## RESPONSE TO REQUEST FOR ADDITIONAL INFORMATION

### APR1400 Design Certification

Docket No. 52-046

RAI No.: 182-8160  
SRP Section: 03.07.01 – Seismic Design Parameters  
Application Section: 3.7.1  
Date of RAI Issue: 08/31/2015

Figure 42 Comparison of Minimum-Required Target PSD for Horizontal Time History and PSD of Time History of Truncated Duration from 3.0 sec to 10.5 sec for HRHF-EW

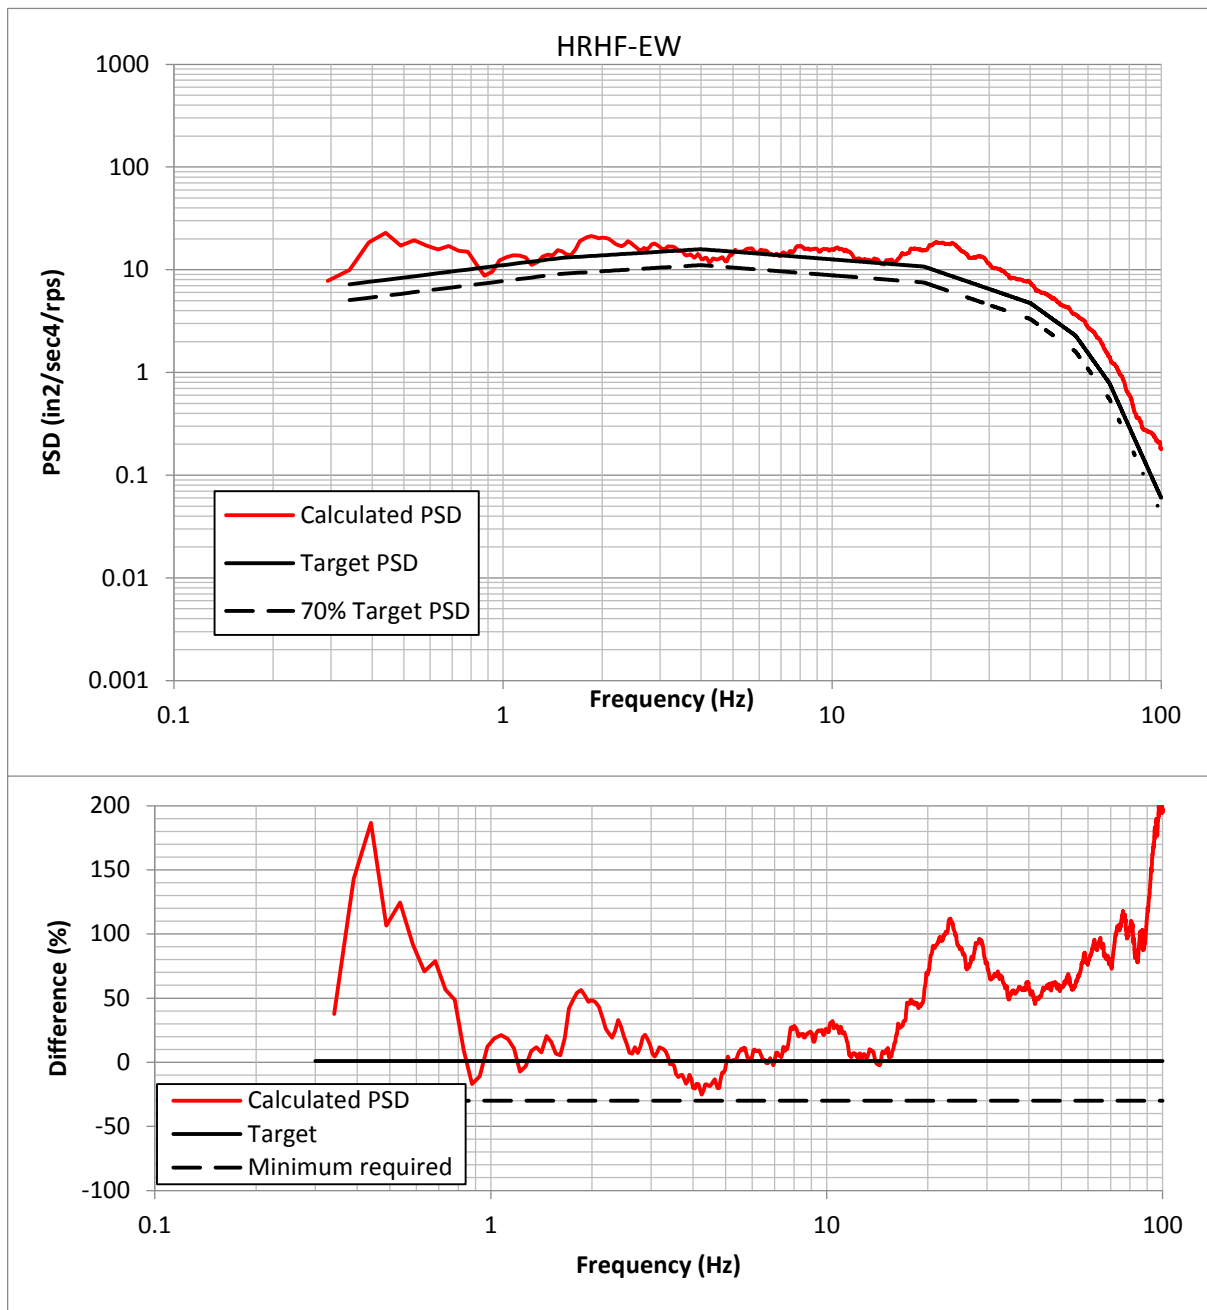
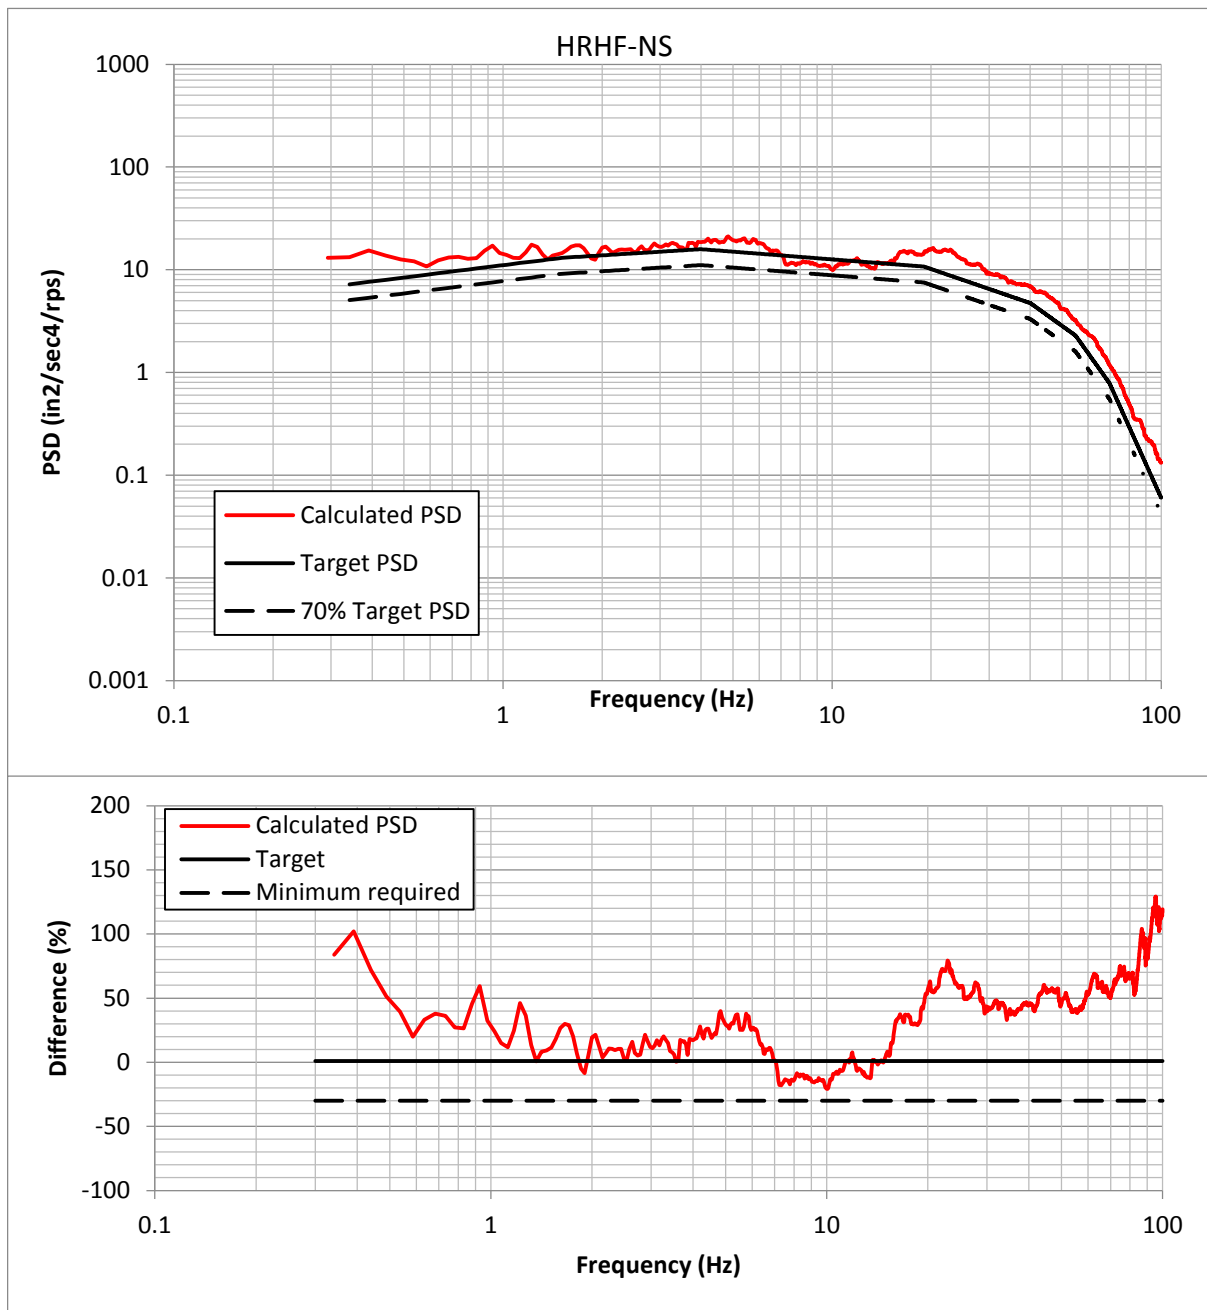
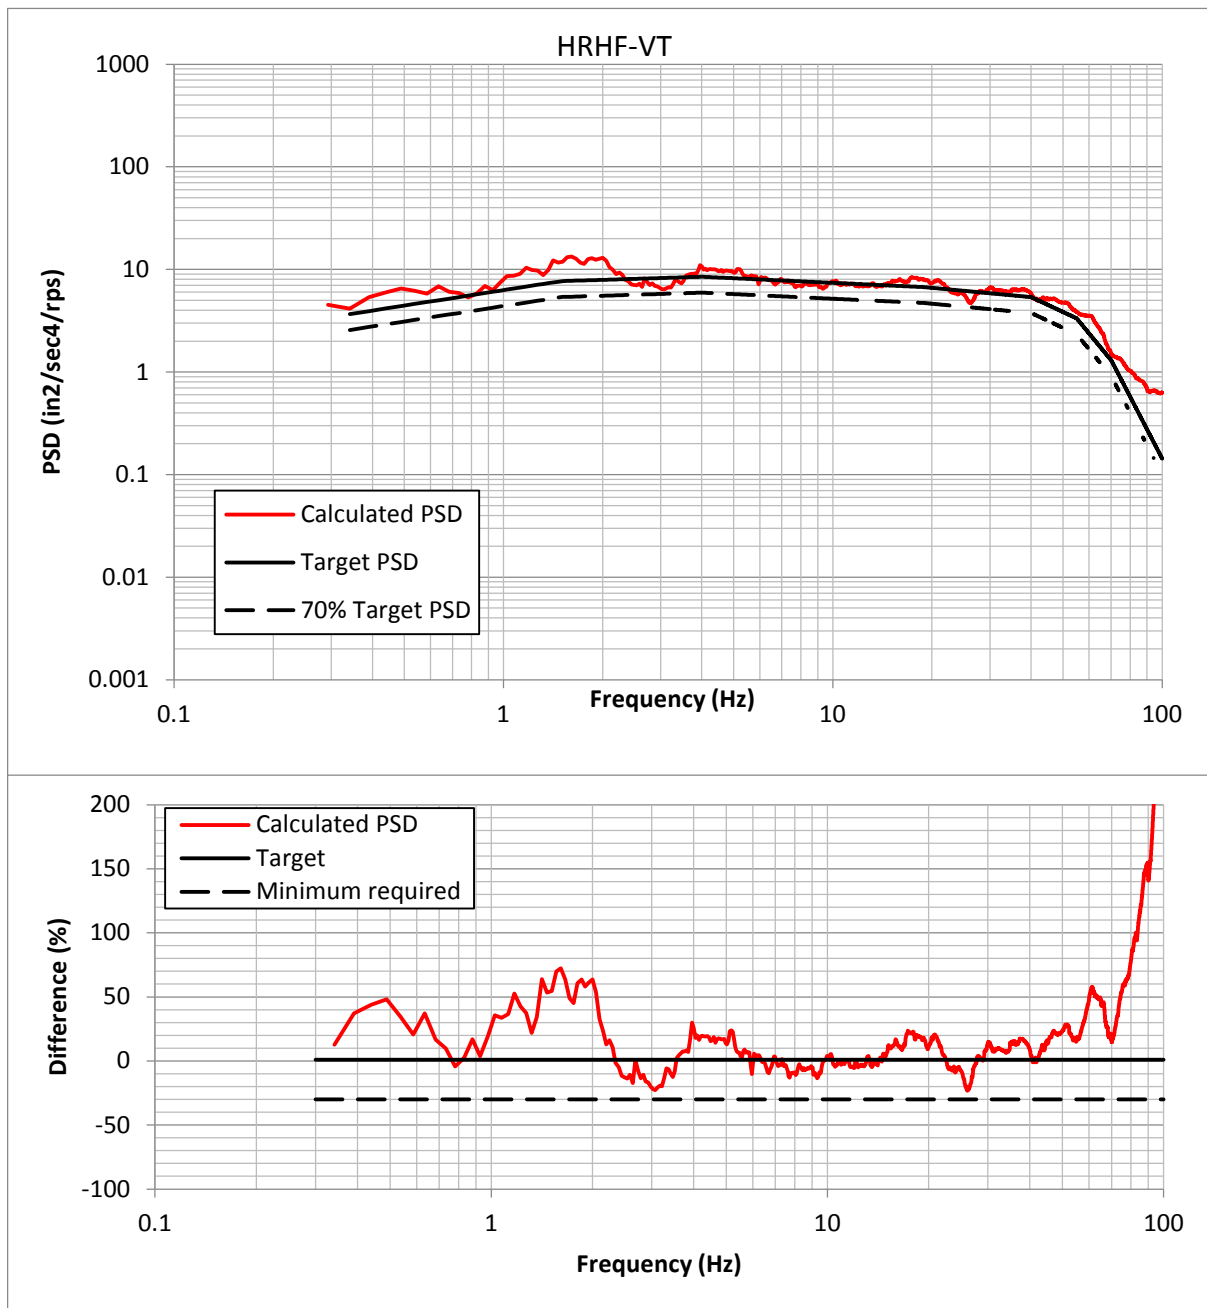
Appendices A and B of SRP 3.7.1 indicate that PSD should be estimated based on the strong motion duration. Therefore, the staff requests that the applicant provide a justification for the use of equivalent stationary strong-motion duration. Similarly, the applicant is requested to explain why the entire time histories were used in the Fourier transform. The use of the equivalent stationary strong-motion duration, which is shorter than the entire duration as shown in Figure 3-27 of APR1400-E-S-NR-14004-P, Rev. 1, together with the entire time history used in the Fourier transform, may overestimate the PSD for those frequencies that have very low magnitude but span the entire time history

The PSDs for the HRHF RS compatible time histories are computed using the procedure which is described in response to Question 03.07.01-3 (a) as shown in Figure 37 through 48. The PSDs for the HRHF RS compatible time histories satisfy requirement of Appendix B of SRP 3.7.1, Rev. 4 as shown in Figure 42, 45, and 48.
